The Commission has issued the enclosed Amendments Nos. 119, 119, and 116 to Licenses Nos. DPR-38, DPR-47 and DPR-55 for the Oconee Nuclear Station, Units Nos. 1, 2 and 3. These amendments consist of changes to the Station's common Technical Specifications (TSs) in response to your request dated November 12, 1982, as supplemented on February 24, 1983.

These amendments revise the TSs concerning the heatup, cooldown and inservice test limitations for the reactor coolant systems of each Oconee unit.

OCONEE NUCLEAR STATION, UNIT NO. 1

SAFETY EVALUATION BY THE OFFICE OF NUCLEAR REACTOR REGULATION
SUPPORTING AMENDMENT NO. 119 TO FACILITY OPERATING LICENSE NO. DPR-38

Figure 3.1.2-3A

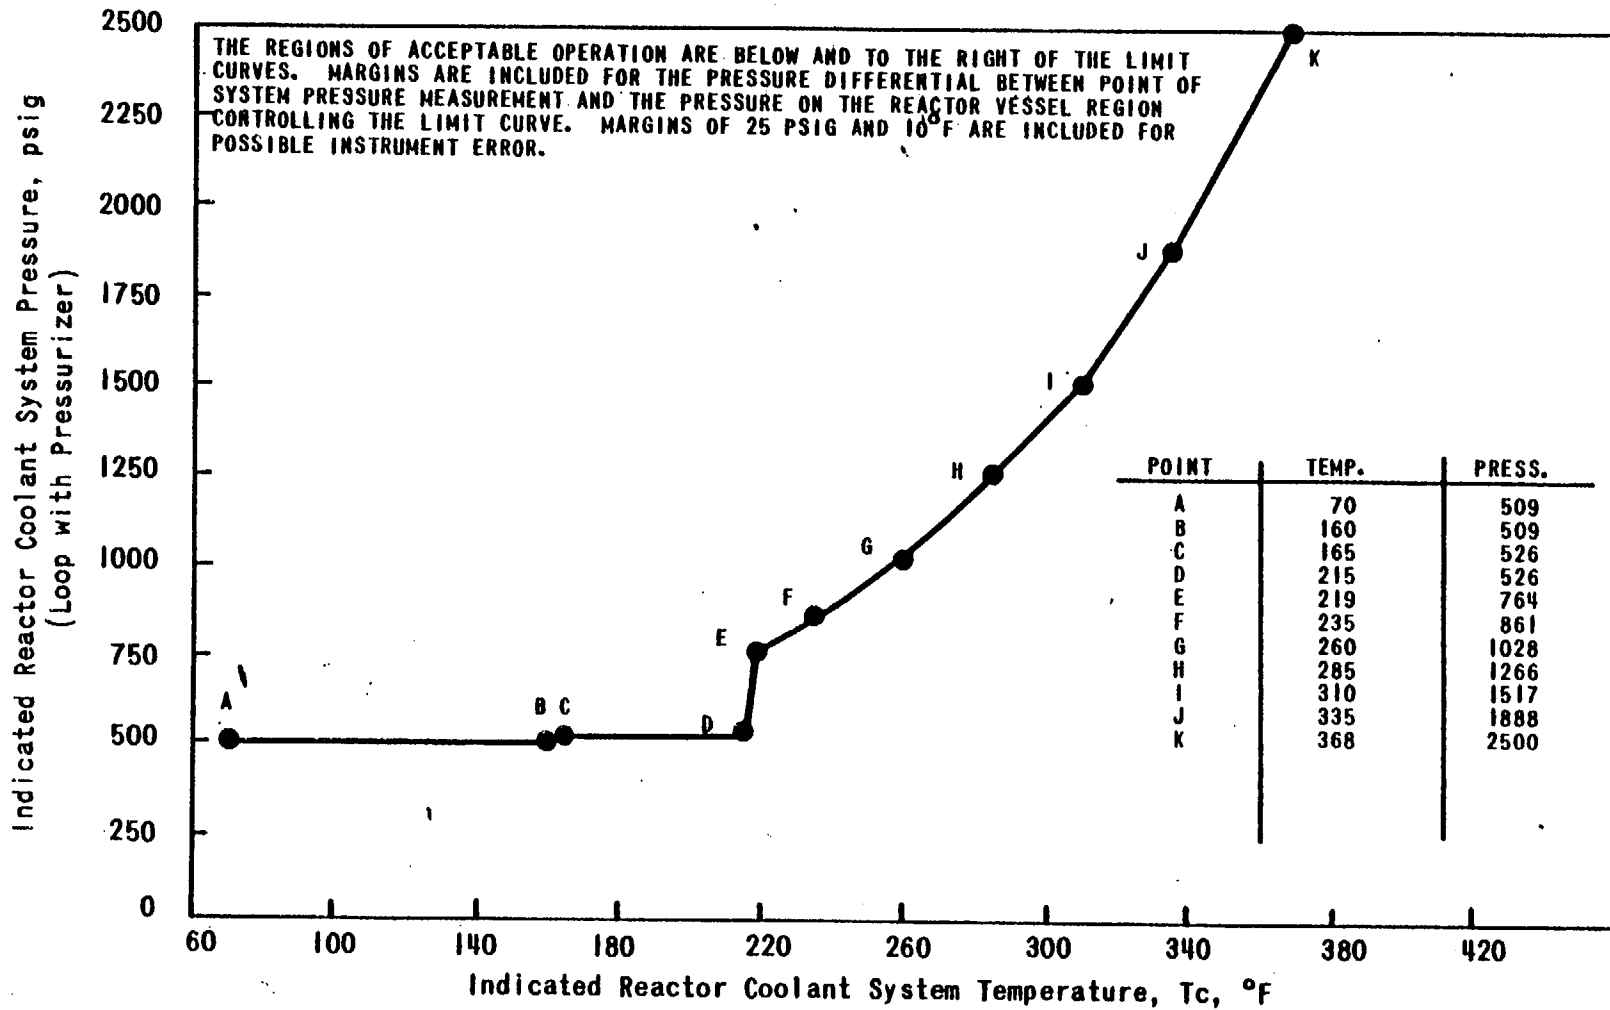
- 3.1.2.2 Leak tests required by Specification 4.3 and ASME Section XI shall be limited to the heatup and cooldown rates and allowable combinations of pressure and temperature provided in Tables 3.1-1, 3.1-2 and Figure 3.1.2-3A Unit 1
3.1.2-3B Unit 2
3.1.2-3C Unit 3
- 3.1.2.3 For thermal steady state system hydro tests required by ASME Section XI the system may be pressurized to the limits set forth in Specification 2.2 and 3.1.2.2.
- 3.1.2.4 The secondary side of the steam generator shall not be pressurized above 237 psig if the temperature of the vessel shell is below 110°F.
- 3.1.2.5 The pressurizer heatup and cooldown rates shall not exceed 100°F/hr. The spray shall not be used if the temperature difference between the pressurizer and the spray fluid is greater than 410°F.
